DATE: 9/24/2026

PROJECT: ATF Dayton Field Office Renovation
Phase 2

ADDENDUM NO. 2

FIRST FLOOR LIGHTING PLAN
SCALE: 1/8" = 1'-0"

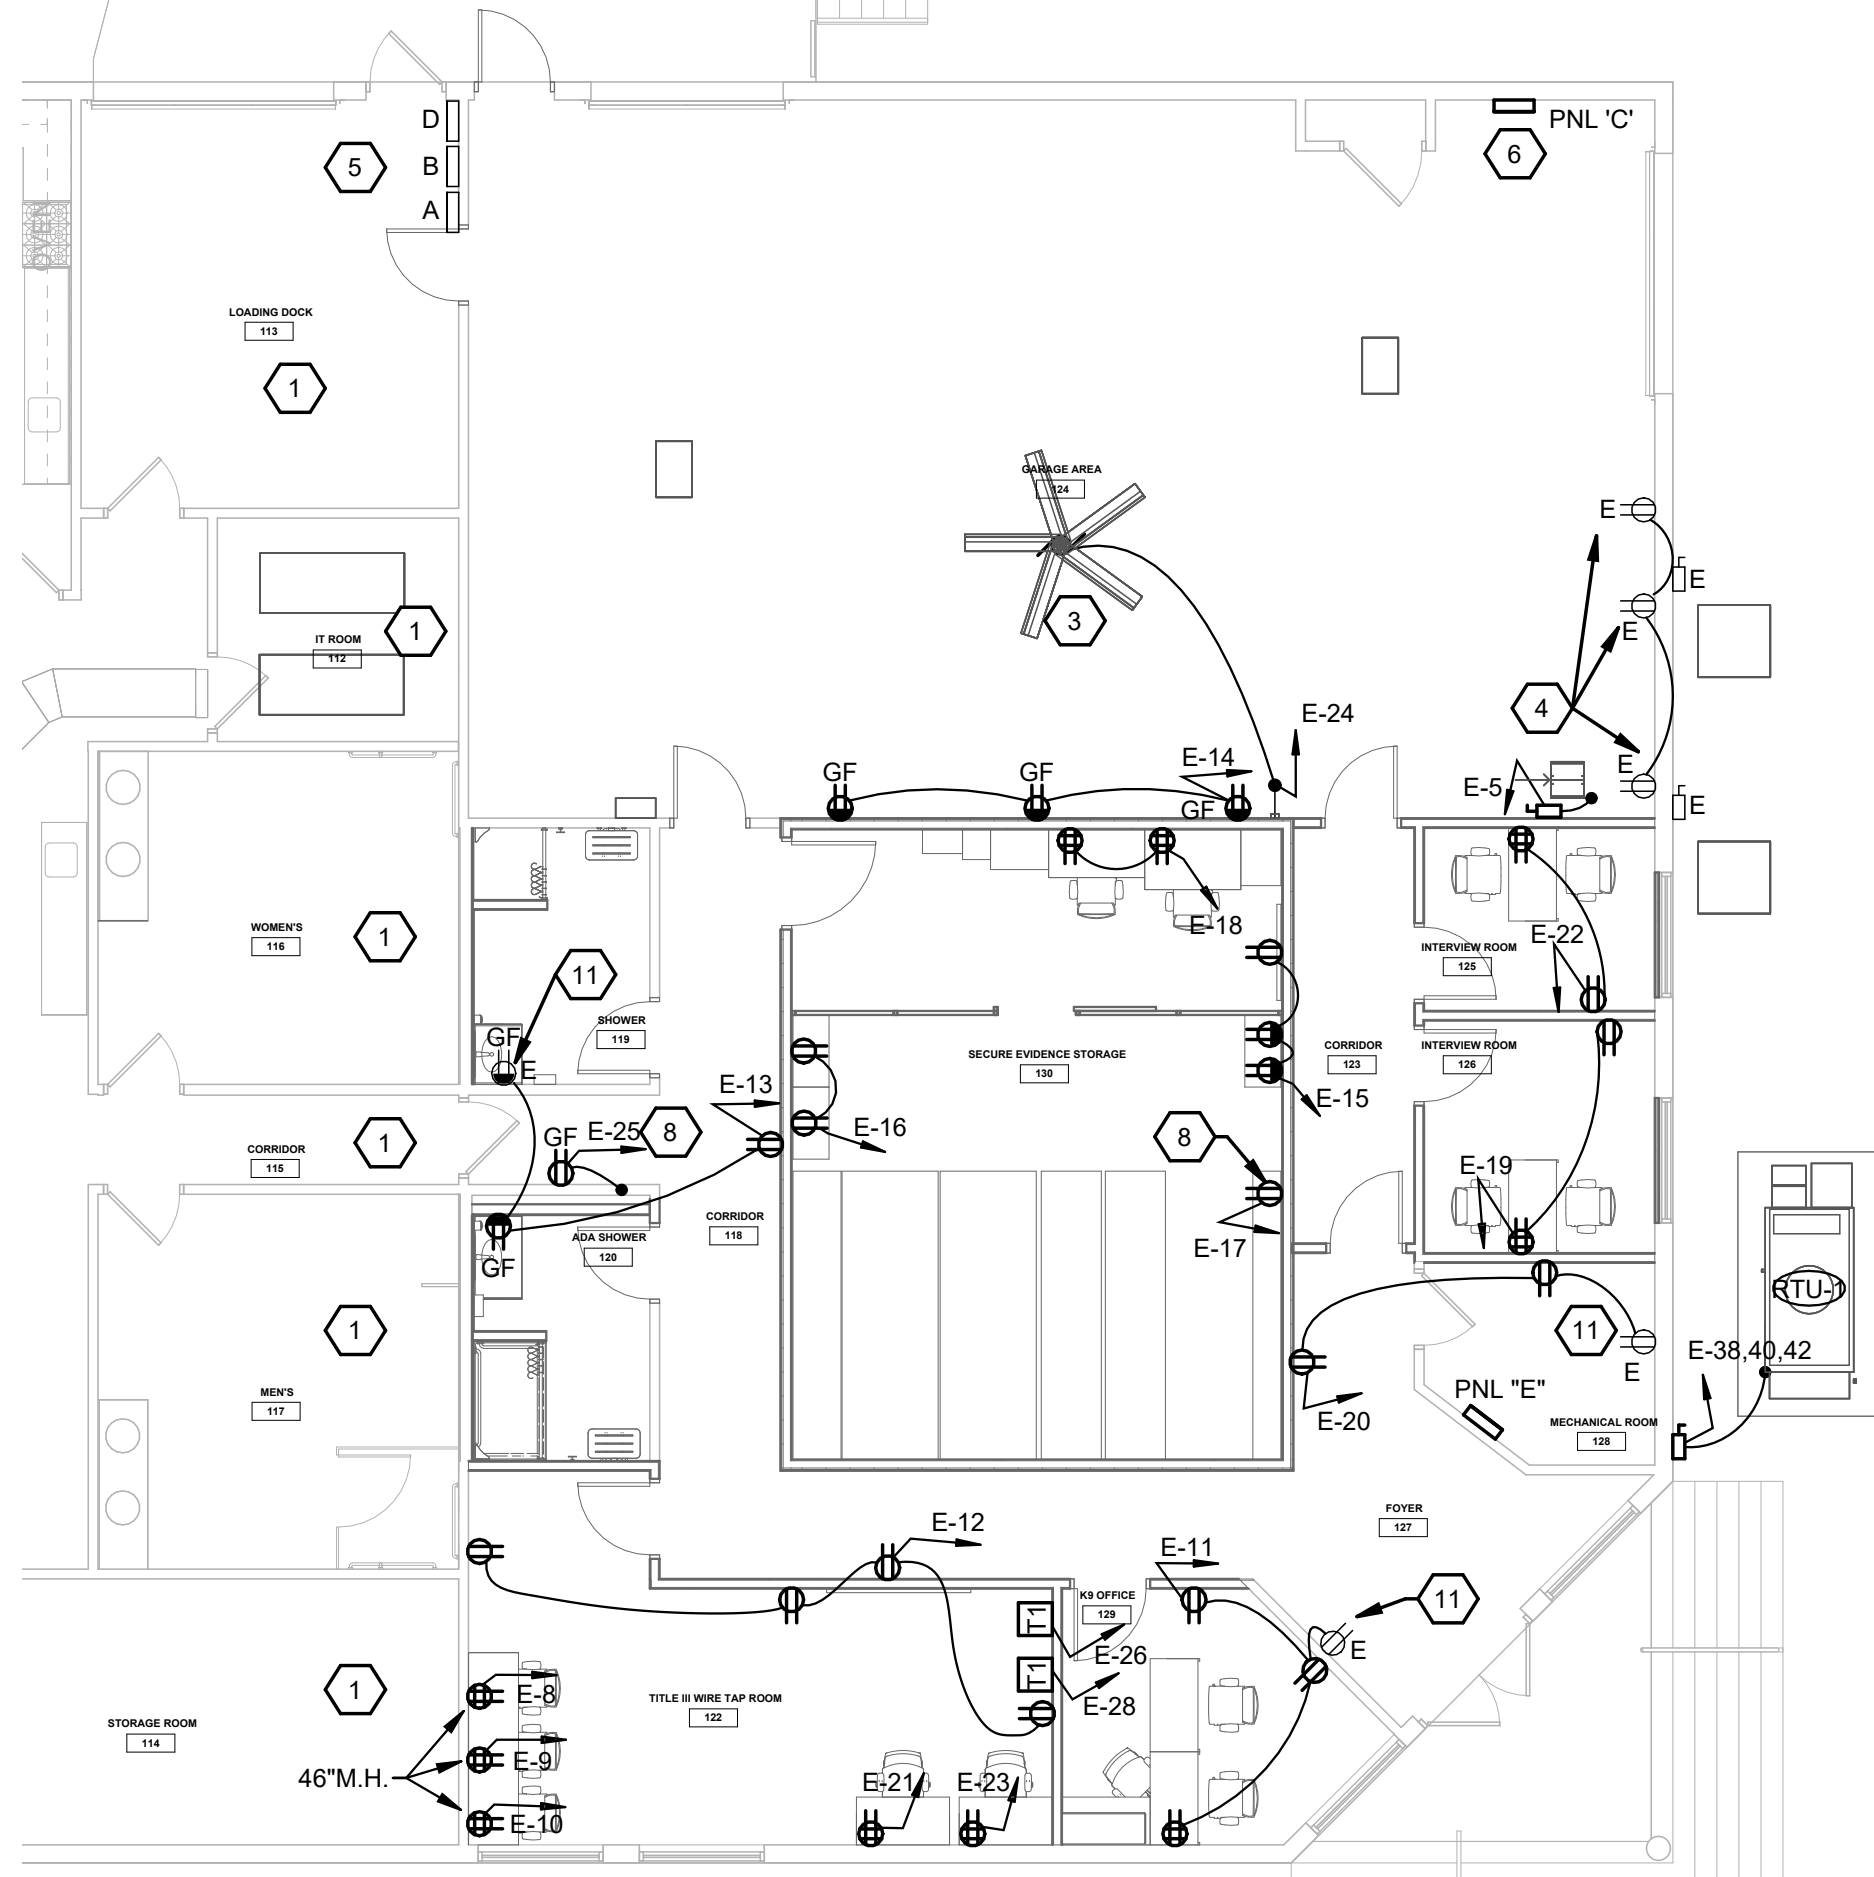
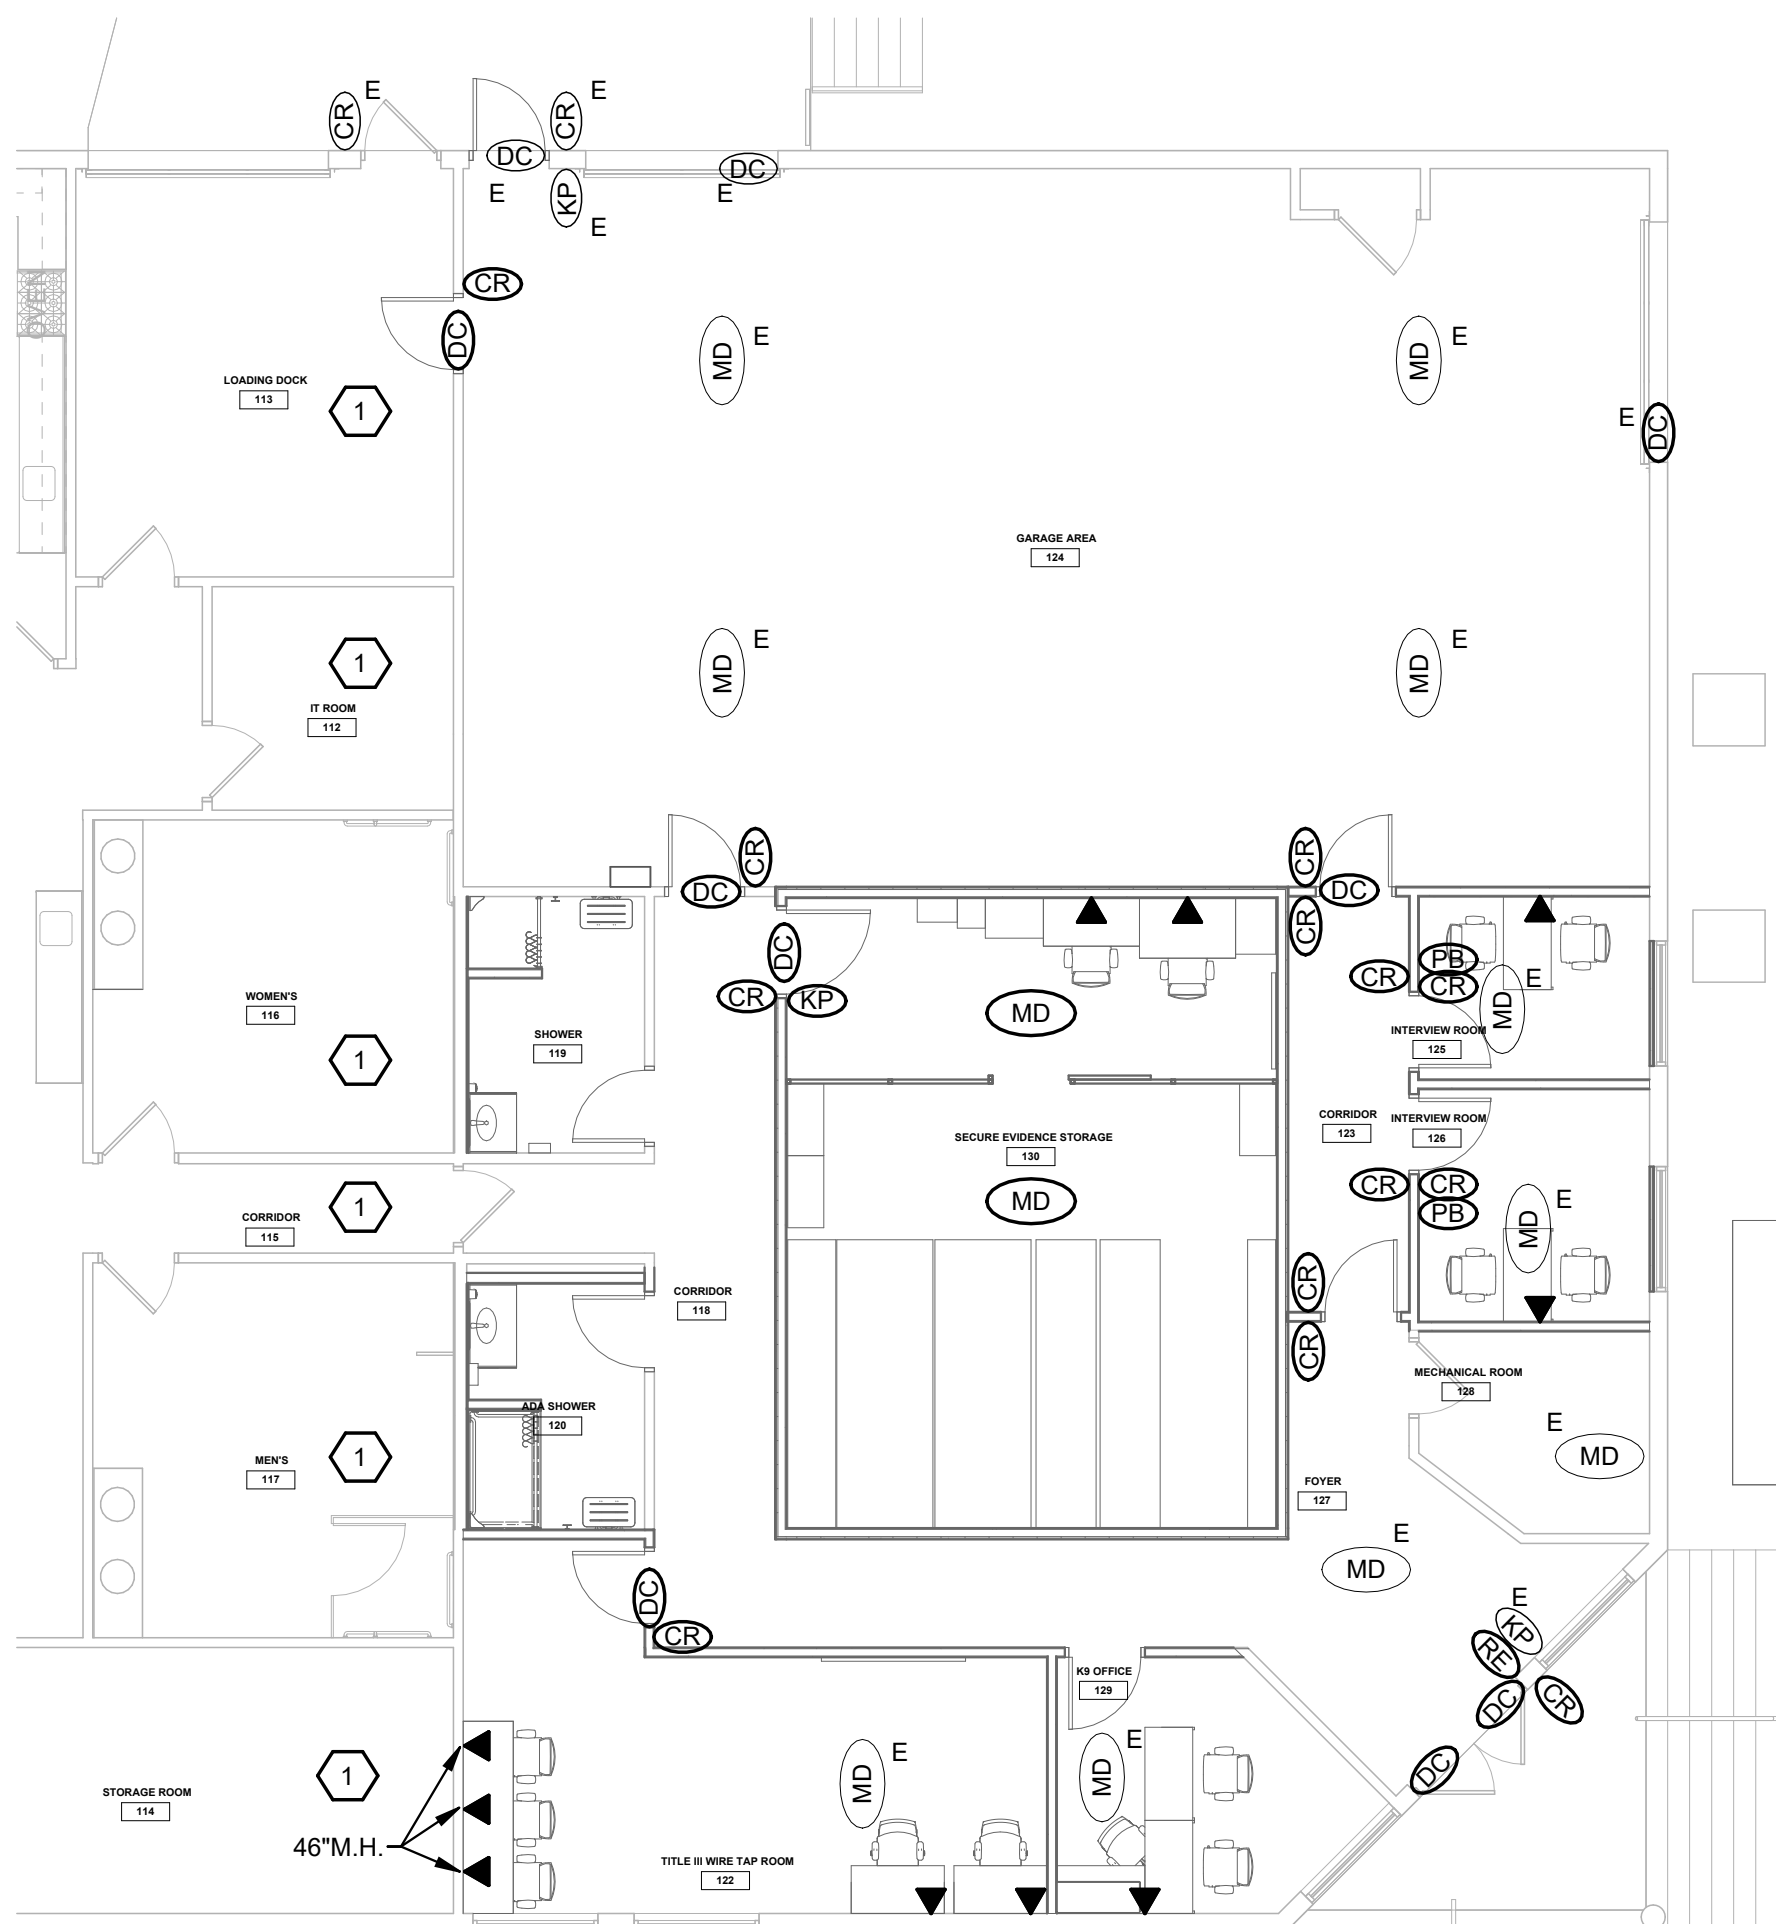
ITEM E2: Sheet E3.1 – NEW WORK POWER PLAN

1. Add ceiling occupancy sensor in Room 122.
2. Add wall vacancy sensor/dimmer in Room 129.
3. Revise lighting layout in Garage Area 124.

Question: Per Drawing E3.1 the Lighting Plan Detail does not have any Lighting Control's or Switches figured for the (2) Office Space's. What will be operating these Office's?

Answer: Provide ceiling occupancy sensor in Wiretap Room(122) (with wall mt'd dimmer). Provide wallbox vacancy sensor/dimmer in Office (129).
